**RE-EVALUATION  
FORM****1. GENERAL PROJECT INFORMATION**A. Re-evaluation Type: Design Change, Construction AdvertisementB. Original approved Environmental Document:**Document Type:** Type 2 CE**Date of Approval:** 11/21/2018**Project Numbers:**

**Project Name:** I-95(SR9) FROM SOUTH OF SR202(JT BUTLER) TO ATLANTIC BLVD**Project Location:** FDOT District 2 ( Duval County )**Project Limits:** I-95 from J. Turner Butler Blvd. to Atlantic Blvd. (6.3 miles)C. Prior Re-evaluation(s):

A Type 2 Categorical Exclusion was completed in November 2018 for the addition of two express lanes in each direction along with select auxiliary lane and ramp terminal improvements. The improvements included removing and replacing the existing pavement, bridges, drainage system, signing, pedestrian overpass, and lighting. Re-evaluation No. 1 (Ponds) was completed and approved in November 2020 to assess project impacts to the proposed stormwater ponds and to document changes in pond locations and reconfigurations. This re-evaluation (Mainline General Use Lanes) assesses

**RE-EVALUATION  
FORM****Figure 4.1.1: PD&E Preferred Alternative Typical Section****Figure 4.1.2: Design Change Alternative (Mainline to General Use Lanes) Typical Section**

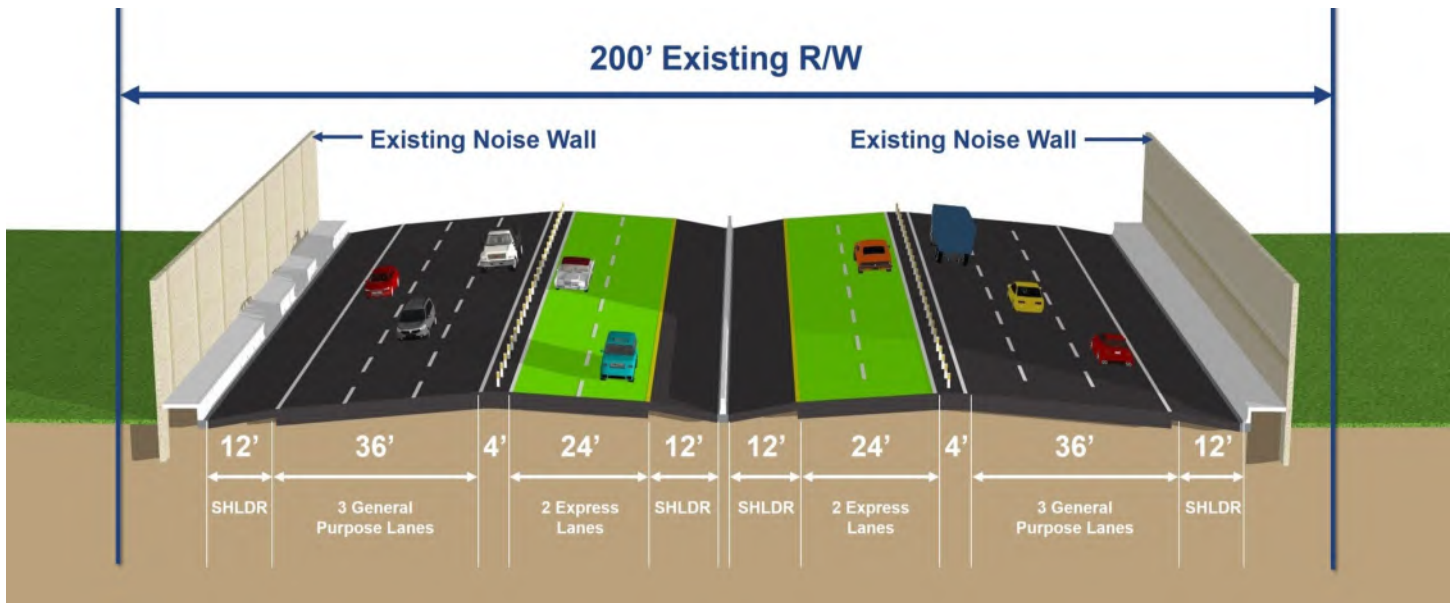
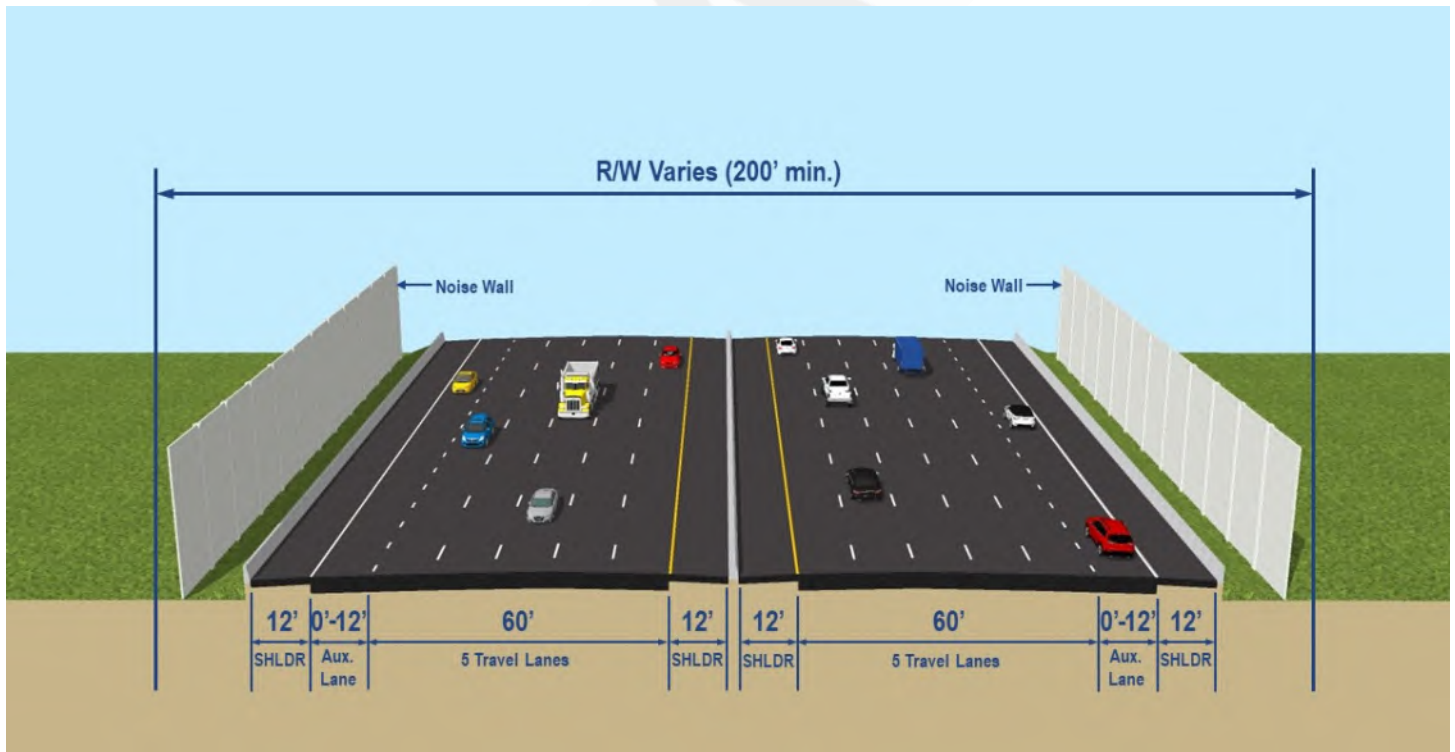
The major design change between the PD&E Preferred Alternative and the Design Change Alternative (Mainline General Use Lanes) is the conversion of the express lanes in the northbound and southbound directions to general use lanes. The elimination of the express lanes removes the four-foot buffer and tubular markers required between the express and general use lanes. The PD&E Preferred Alternative typical section is shown in Figure 4.1.1. The Design Change Alternative (Mainline General Use Lanes) typical section shown in Figure 4.1.2 includes five general use lanes and one intermittent auxiliary lane in each direction. These changes resulted in:

- A reduction in required right-of-way;
- Removal of tolling sites;
- Removal of flyover ramp from westbound JTB to northbound I-95 Express Lanes;
- A reduction of noise walls requiring replacement; and
- Removal of the shoulder width design exception on the Overland Bridge by tying into the existing pavement north of the San Diego Road overpass. This change reduces the northern project limits by approximately 3,100 feet and avoids restriping of the newly constructed Overland Bridge.

The Design Change Alternative (Mainline General Use Lanes) typical section includes five general use lanes and one intermittent auxiliary lane in each direction. The proposed improvements begin 2,320 feet south of the interchange with JTB, where a single lane is added to the existing three lane section in the northbound direction by widening into the median. Proceeding northward, a five-lane section is formed when the existing parallel-type entrance ramp from westbound JTB joins northbound I-95. Just south of this ramp gore, the inside widening beginning south of JTB joins full pavement reconstruction and continues northward.

The PD&E Preferred Alternative, as originally proposed, required restriping of approximately 3,100 feet of the recently completed Overland Bridge project. A shoulder width design exception was also required. The removal of the express lanes no longer requires this restriping for additional capacity and eliminates the need for the shoulder width design exception.
